Solicitation Addendum

Addendum No.:	3
Solicitation No.:	21-TA003799DJ
Project No.:	6067781
Solicitation Title:	Braden Woods Lift Station Upgrade and New Force Main
Addendum Date:	September 1, 2021
Procurement Contact:	Dave Janney Senior Procurement Agent

TOPOGRAPHIC SURVEY
BRADEN WOODS LS / CLUBHOUSE DRIVE FM
MANATEE COUNTY, FLORIDA
COVER SHEET

PROCESS MECHANICAL LIFT STATION UPPER AND LOWER PLAN		BRADEN WOODS LIFT STATION REHAB MANATEE COUNTY BRADENTON, FLORIDA 34205		TAO FU PE 63138		643 SW 4TH AVE, SUITE 400 GAINESVILLE, FLORIDA 32601 EB2822	
1" = X'									
VERIFY SCALE BAR IS ONE INCH ON ORIGINAL DRAWING. 0"  1"									
DATE		MAY 2021							
PROJ		D33391100							
DWG		D-201							
SHEET		25 of 36

TOPOGRAPHIC SURVEY
BRADEN WOODS LS / CLUBHOUSE DRIVE FM
MANATEE COUNTY, FLORIDA
PLAN SHEET

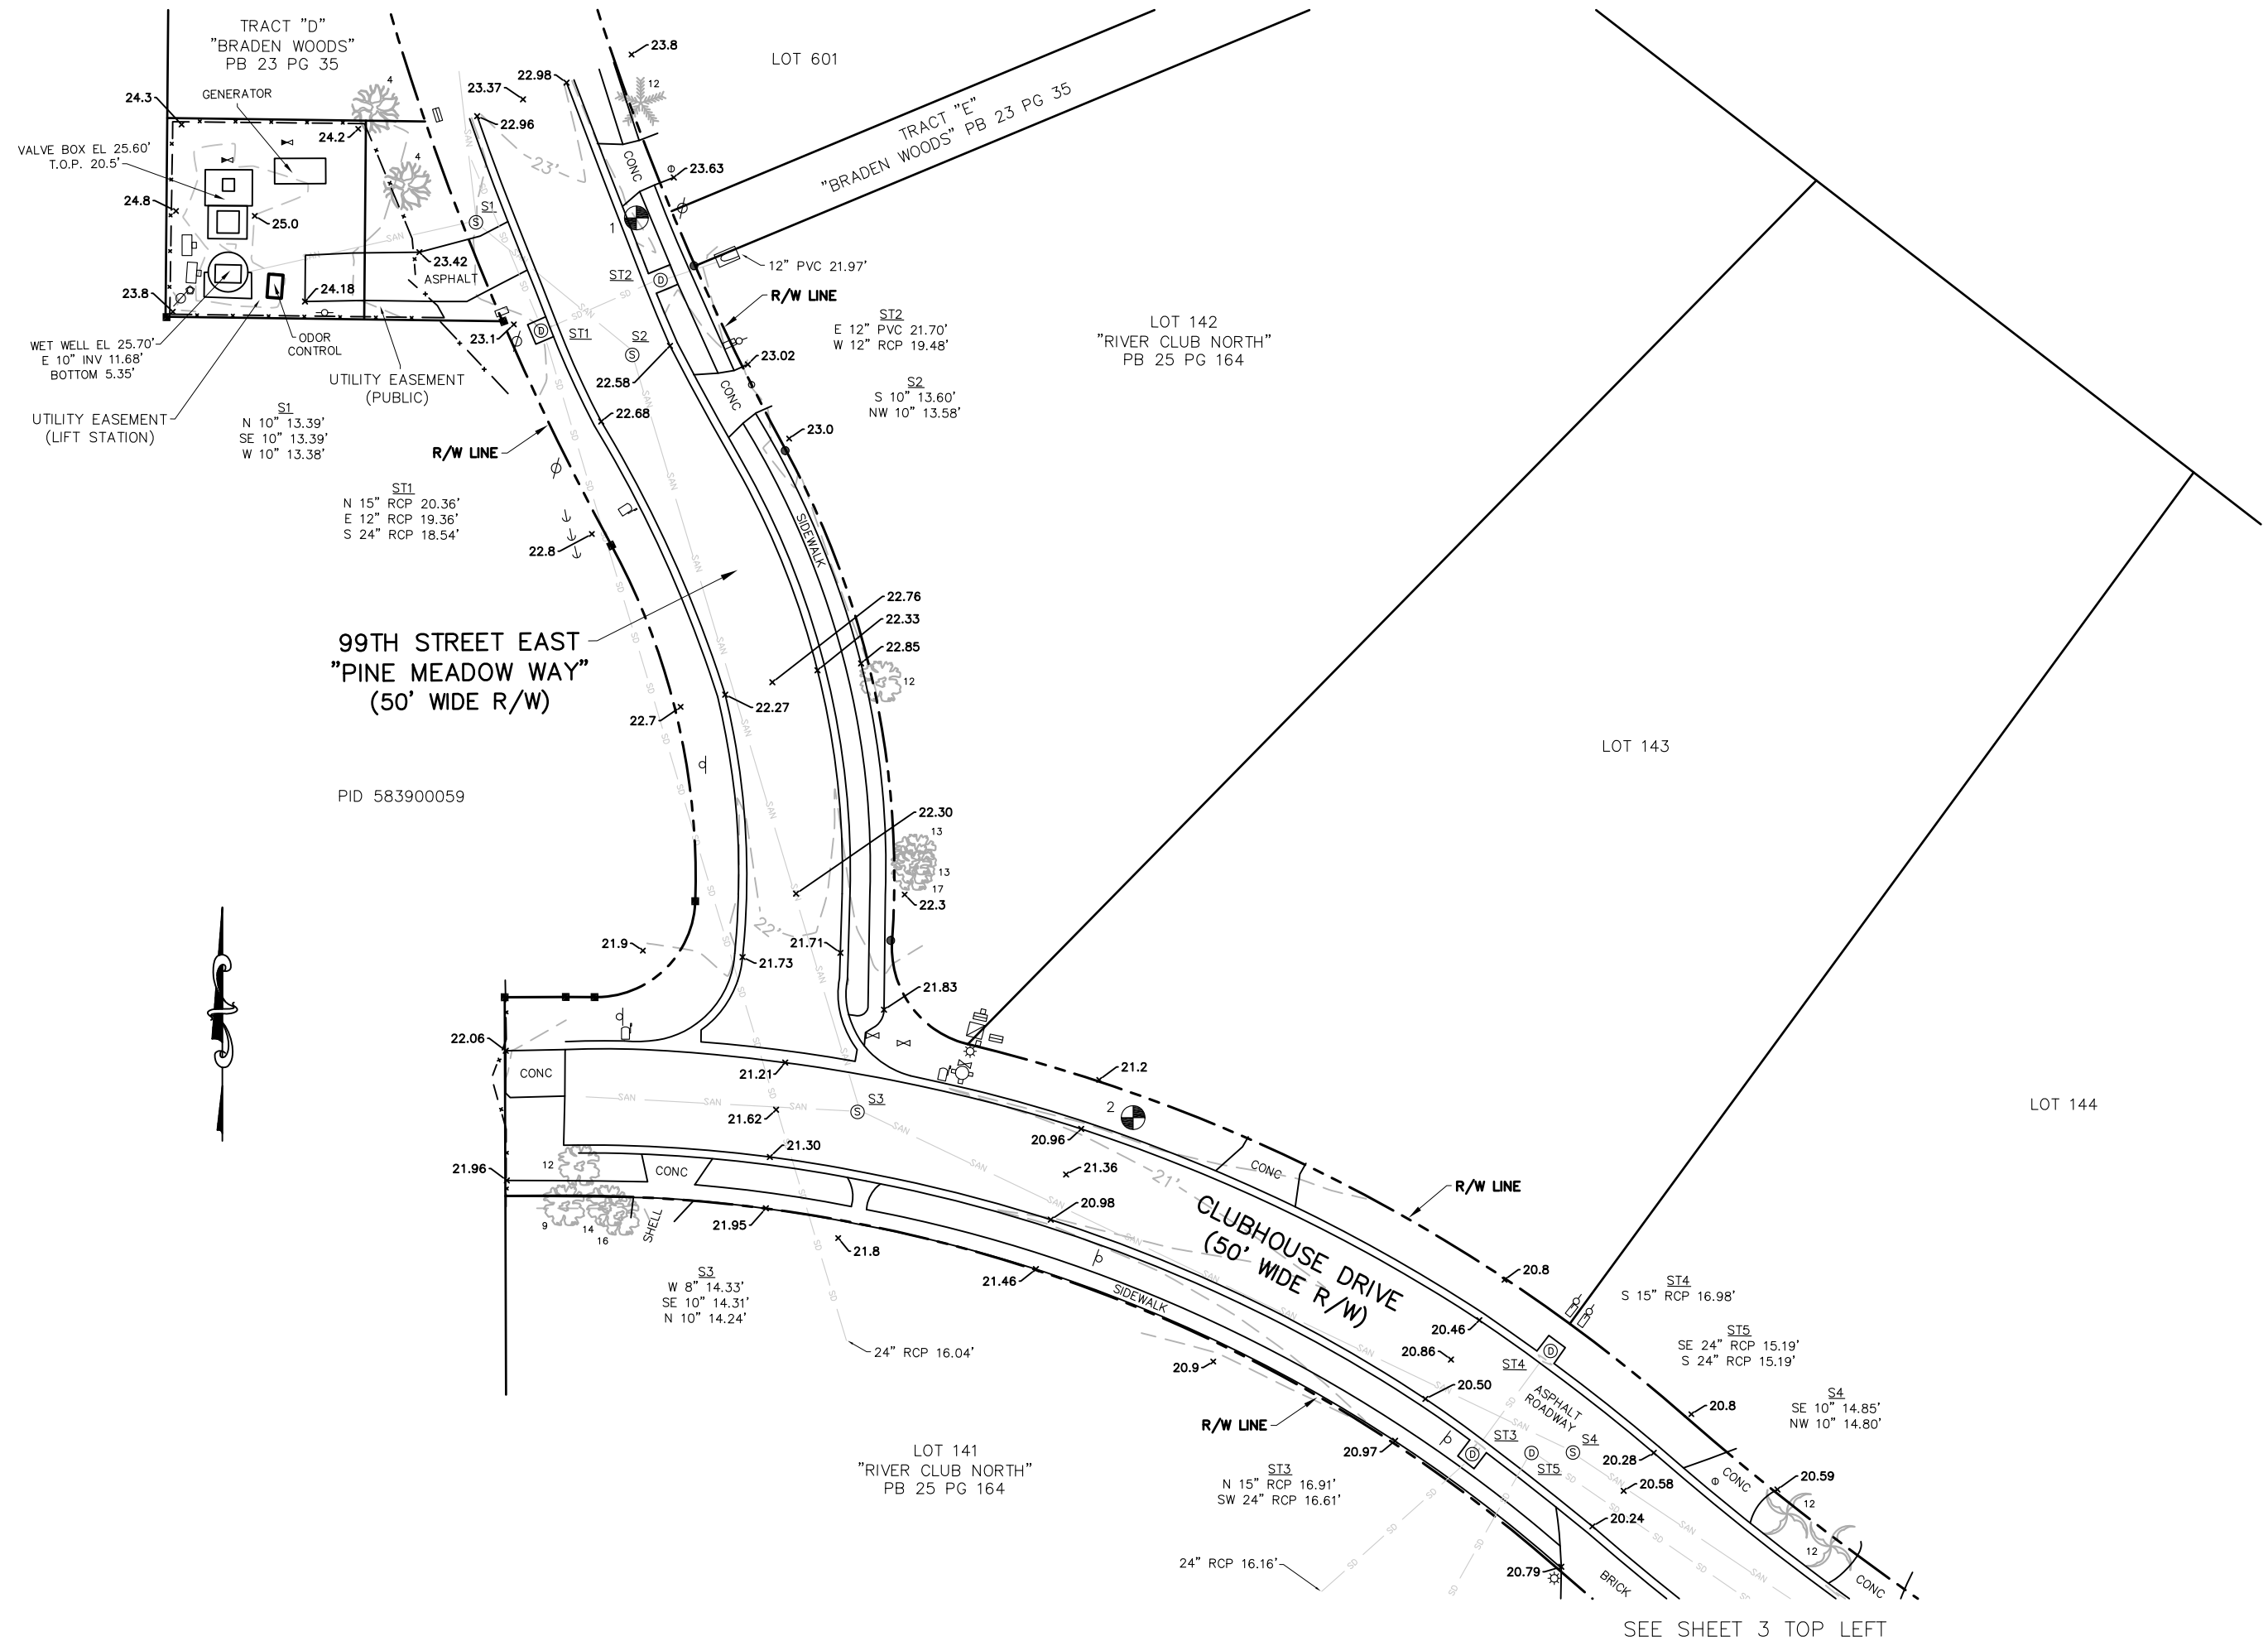
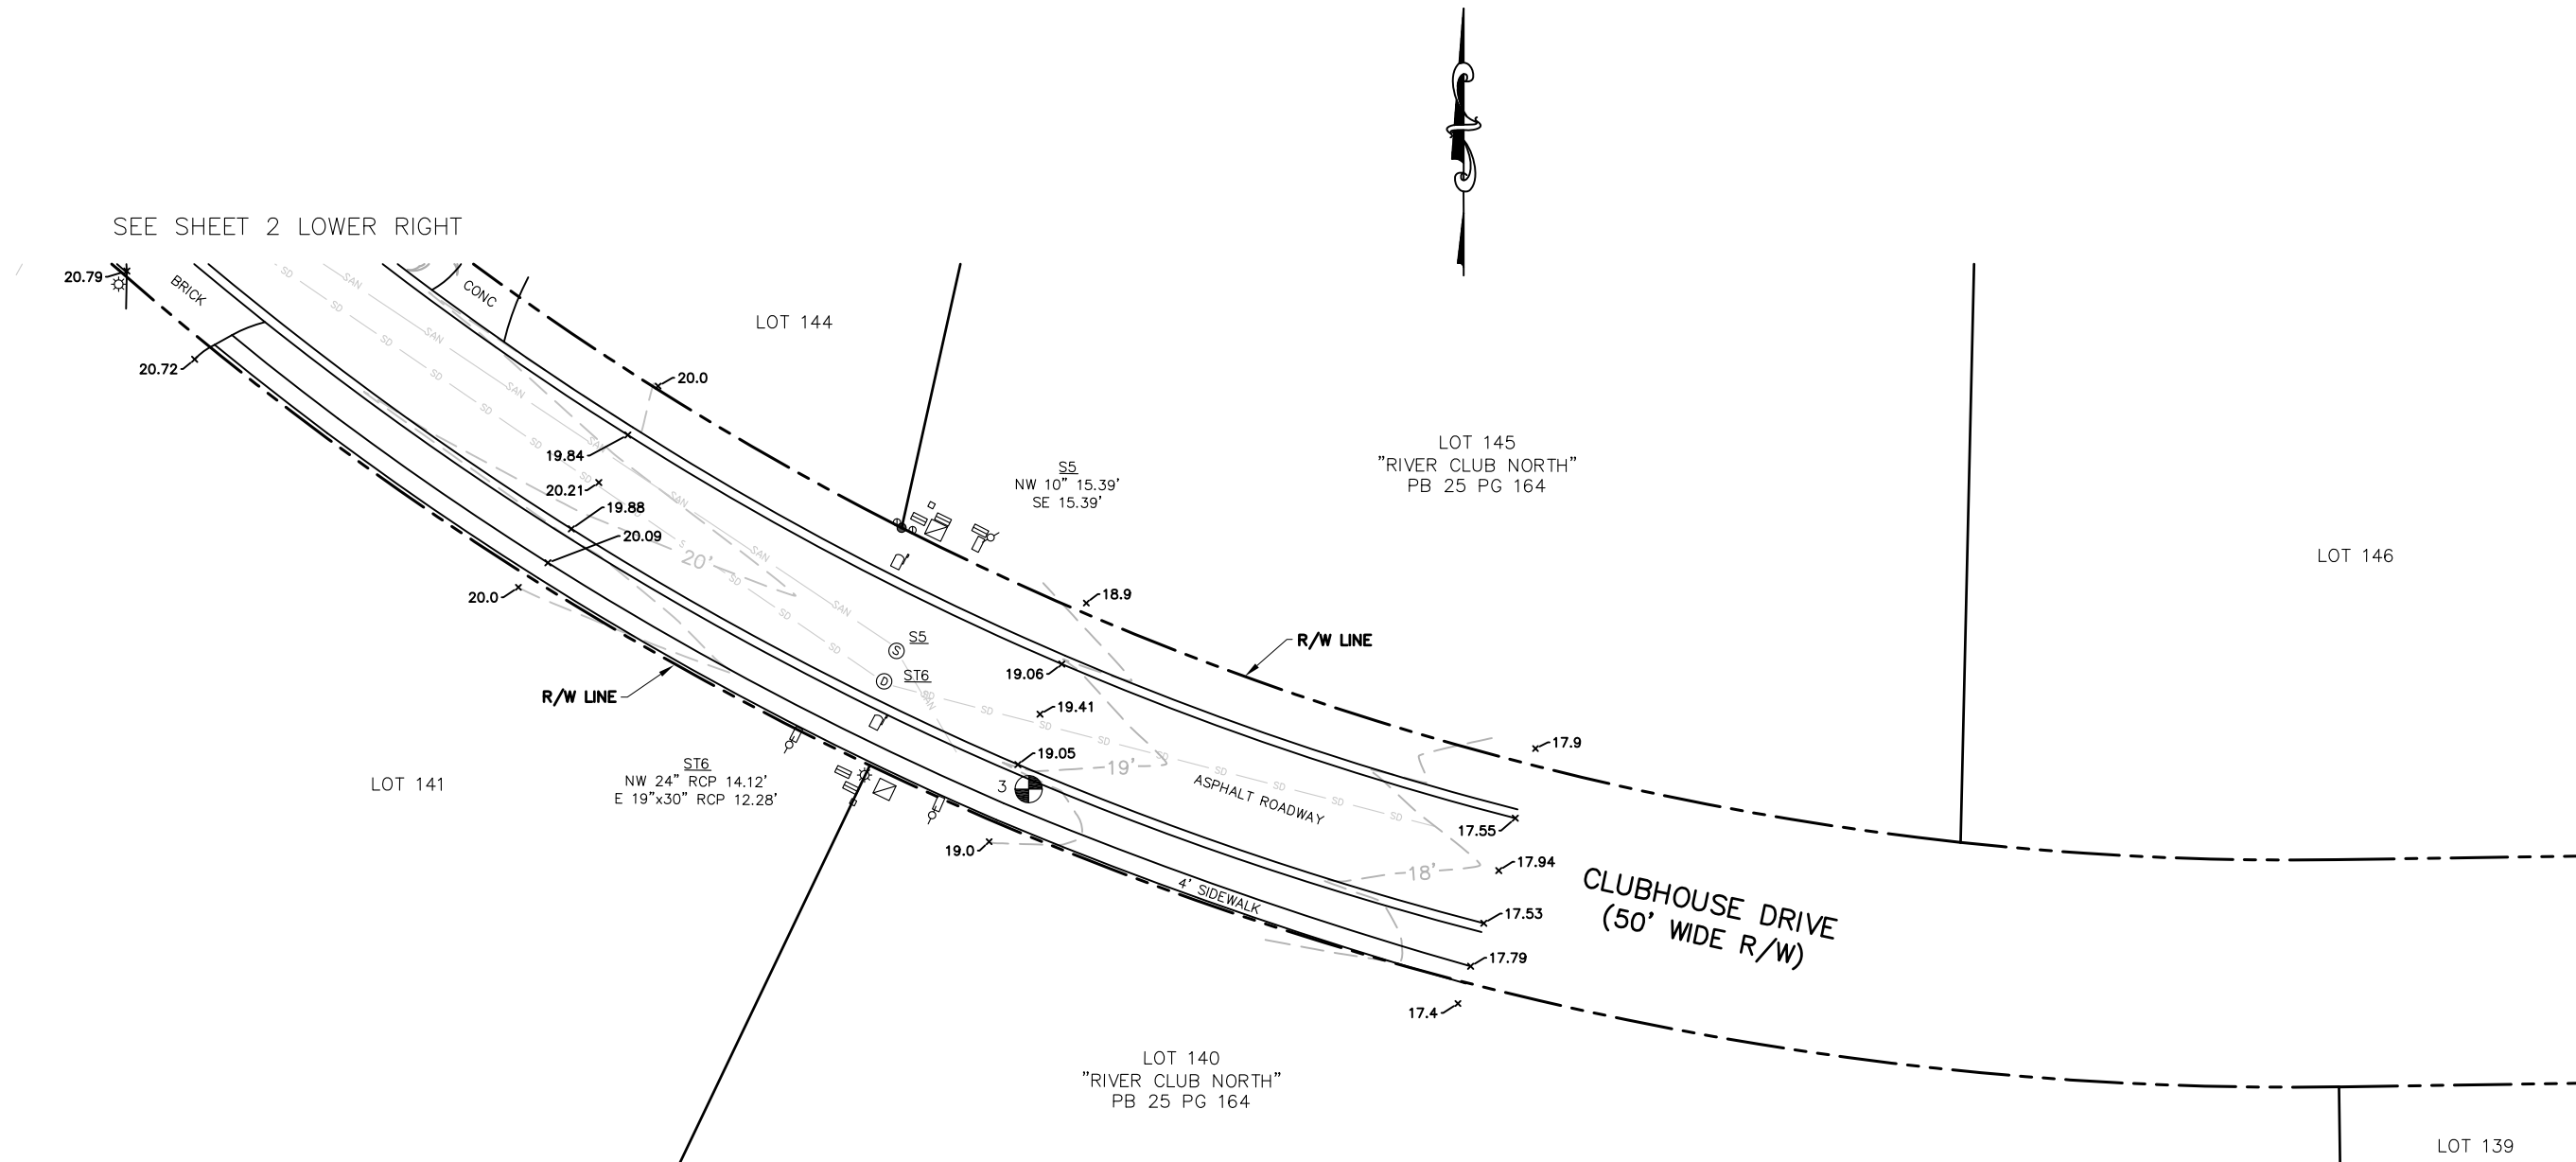
Q4. The plans call out 5 existing manholes to be rehabilitated, but there is no rim or invert information concerning the depth of the manholes. Can this information be provided? Please advise.

Q7. During the site visit and inspecting the five existing manholes that are called out to be rehabbed, the three manholes that are located on Clubhouse Dr. and the one on Pine Meadow Way appeared to already have a spray-applied liner with three having ring and covers dated 2020, and the fourth manhole where the existing FM dumps in, has a polymer ring and cover. Are we to rehab already rehabbed manholes? Please advise.

R4. See Bid Attachment 4 Topographic Survey issued with this Addendum 3 and available for download as a separate attachment.
